RS-01-303

Dresden Nuclear Power Station, Units 2 and 3  
Facility Operating License Nos. DPR-19 and DPR-25  
NRC Docket Nos. 50-237 and 50-249

Quad Cities Nuclear Power Station, Units 1 and 2  
Facility Operating License Nos. DPR-29 and DPR-30  
NRC Docket Nos. 50-254 and 50-265

Subject: Revision to Proprietary Designation - Additional Plant Systems Information  
Supporting the License Amendment Request to Permit Up-rated Power  
Operation, Dresden Nuclear Power Station and Quad Cities Nuclear  
Power Station

Figure 9-1  
DNPS Short Term Core Spray NPSH

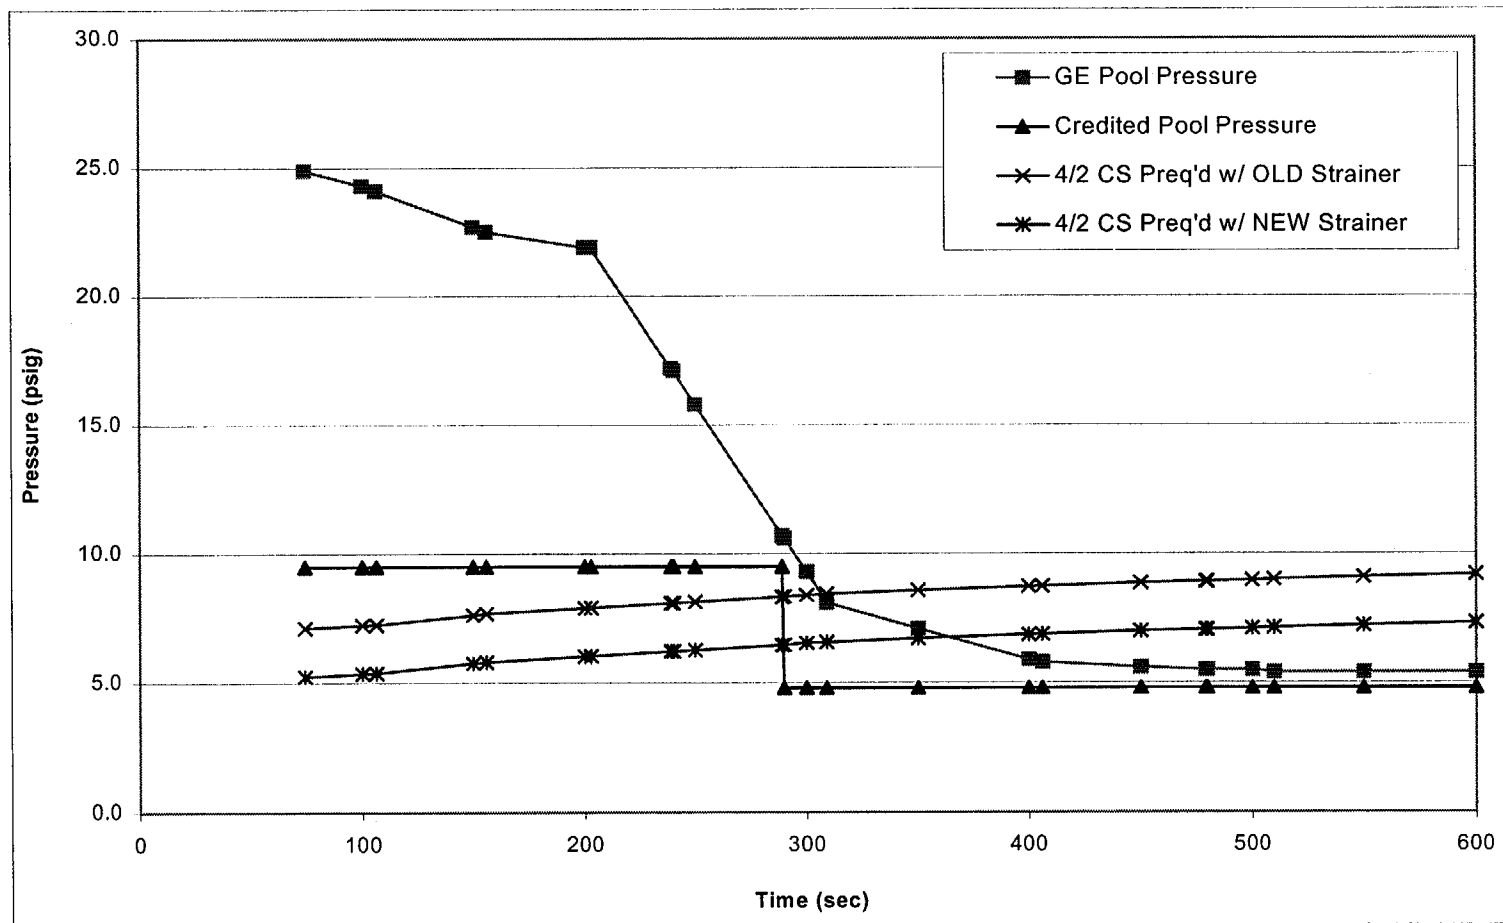
*9. Provide the emergency core cooling system (ECCS) pumps net positive suction head (NPSH) calculations to support the requested additional credit for overpressure. Discuss the increased need for containment overpressure for NPSH following a design basis accident. Describe the procedures or equipment in place that will allow continued cooling flow with the drywell potentially depressurized to atmospheric conditions and the suppression chamber at the most conservative pressure associated with vacuum breaker operation (limiting case either torus/drywell or torus/reactor building). Additionally, discuss the methodology for determining the requested containment overpressure, including the headloss across the ECCS suction strainers.*

The graphs showing the results of the ECCS NPSH calculations for the limiting short term and long term flow cases are provided in Figures 9-1 and 9-2. Core spray flow is the limiting NPSH case in the short term, and LPCI flow is limiting for NPSH in the long term. Figures 9-1 and 9-2 also show NPSH required (NPSHr) for both the old strainer and new strainer cases (e.g., one blocked, three clean). The higher head loss of the old strainers, as indicated above, is the basis for the requested overpressure.

In the short term, there is a period from approximately 290 seconds to 600 seconds during which some ECCS pump cavitation can occur, since the available NPSH is less than the required NPSH. This period is after the time at which the peak cladding temperature (PCT) has been reached at approximately 240 seconds. Prior to 290 seconds, the requested overpressure ensures that adequate NPSH is available to meet the core cooling requirements assumed in the PCT calculations. After 600 seconds, ECCS pump throttling restores adequate NPSH. Pump cavitation for the brief time from 290 seconds to 600 seconds is not of concern due to short duration of the cavitation.
